2009 Corvette Z06 and ZR1: GM TechLink Article: Oil System Changes - LS7 and LS9

Changes have been made to the dry-sump engine oil system used in the 2009 Corvette

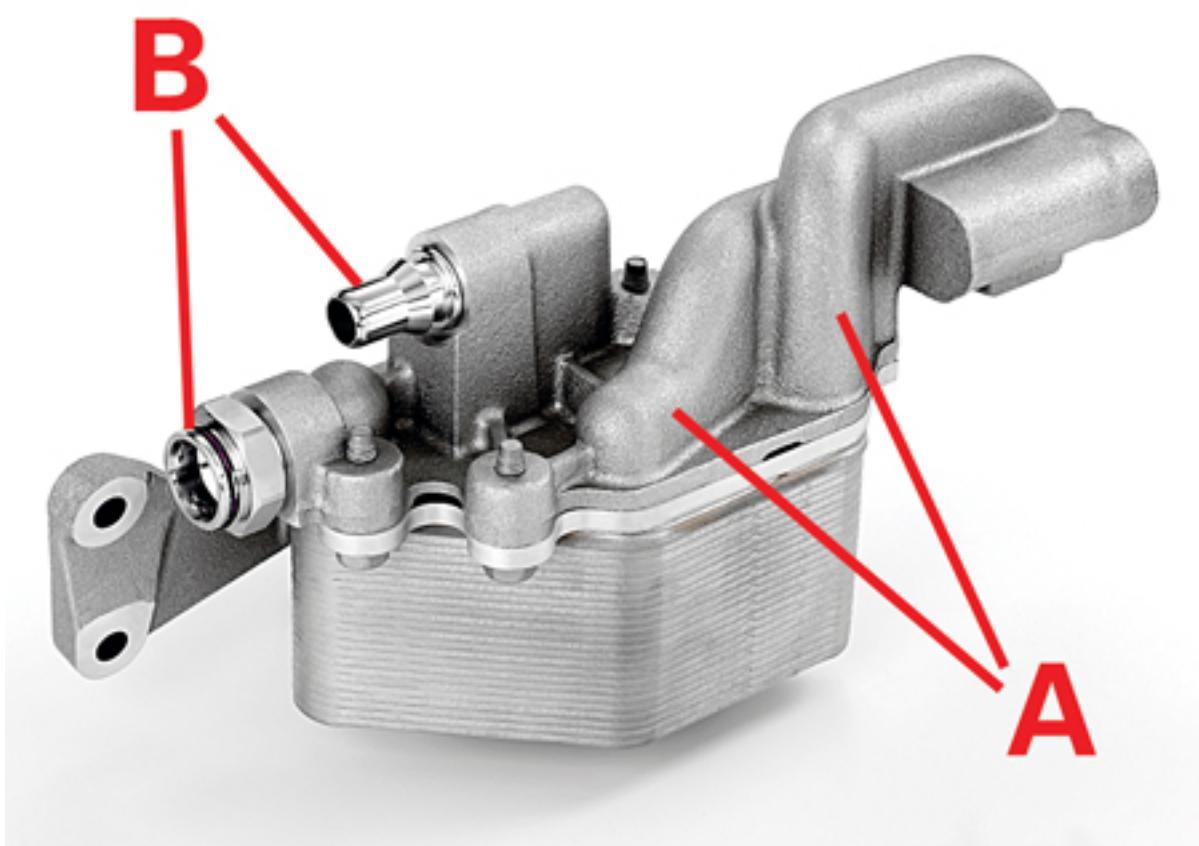
The dry sump system uses a dual gerotor oil pump, one rotor for scavenge and one rotor for supply (fig. 2) . The pump used on the LS9 produces greater volume and higher system oil pressure to provide adequate oil delivery under all conditions.

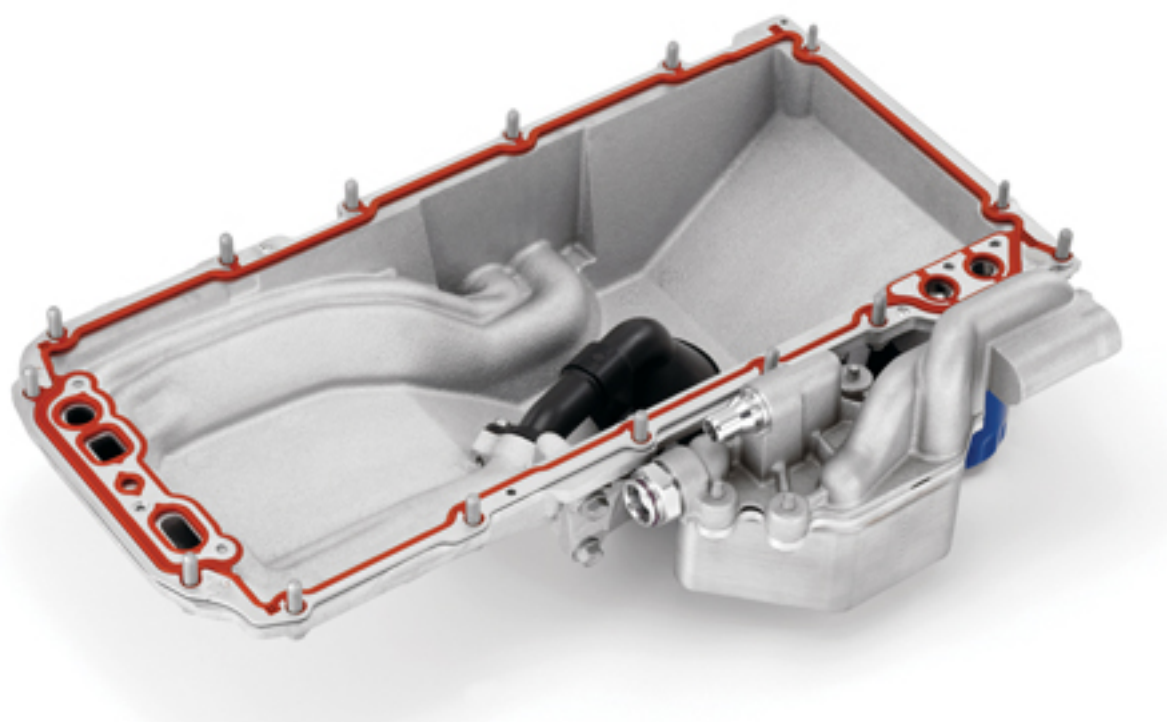
The LS9 uses eight oil squirters, one per cylinder, for additional lubrication of the pistons and cylinder walls (fig. 3) .

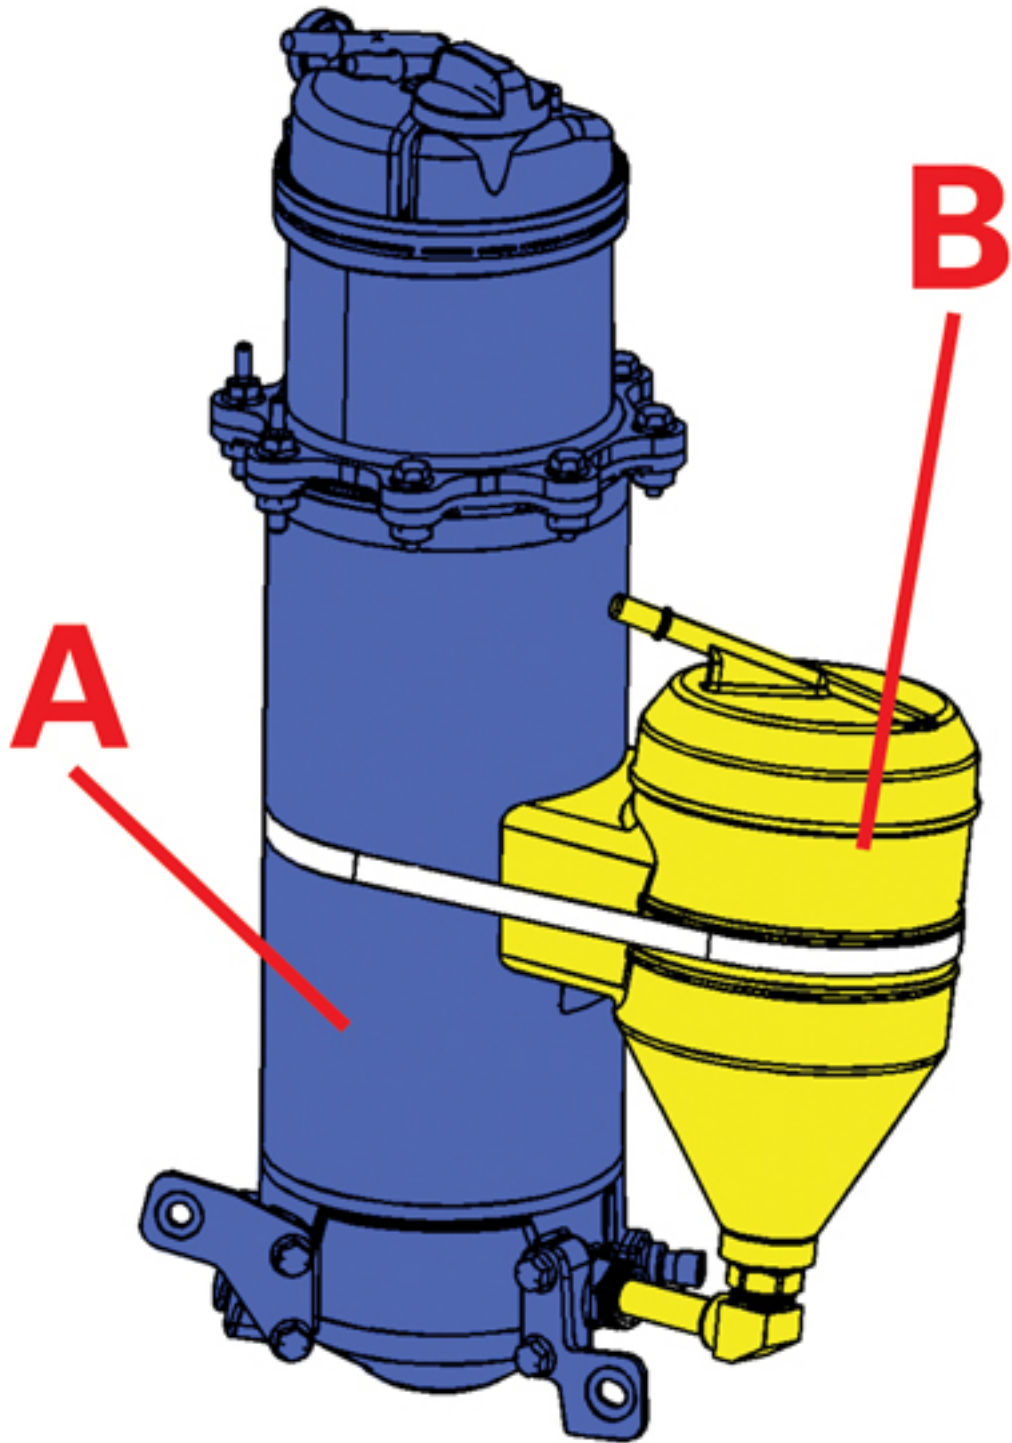
For both engines, the oil reservoir has been redesigned to increase the oil capacity of the system. Under extreme cornering loads such as experienced on a banked race track, extra oil capacity ensures that there is sufficient oil in the reservoir to avoid the ingesting of air due to slosh. A second tank is connected to the main tank by tubing (fig. 6) .

A Original reservoir

B Added capacity

Due to the revised oil reservoir, on both engines the oil capacity is now 10.5 quarts instead of 8.0 quarts, but otherwise the oil change procedure remains the same. Remember, there are two drain plugs in the oil pan. The one on the front of the pan drains the external reservoir and hoses. The other plug near the oil filter drains about a quart of residual oil from the pan. Refer to SI for details.
